Connection Assessment Report for LV Shunt Capacitor Installations

Connection Applicant: Hydro One Networks Inc.

CAA ID 2002-EX019

Final Report

Figure 1. Proposed Connection Arrangements

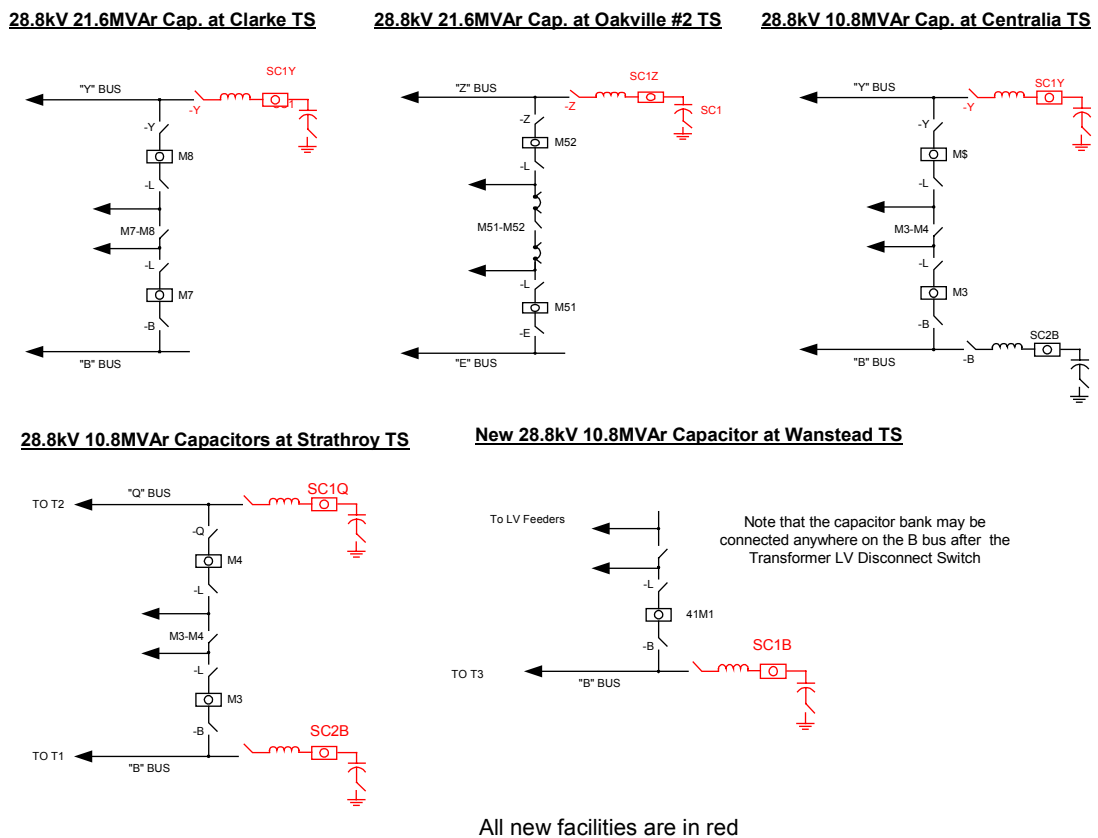
The synchronizing breakers are vacuum type, with a continuous rating of 1200 A and an interrupting capability of 25 kA. It is assumed that the breakers are ganged-pole breakers, hence no special features are provided for synchronized opening or closing.

Hydro One has indicated that the series reactors (1mH per phase) were sized to ensure that the in-rush currents do not exceed the breakers' interrupting capability.
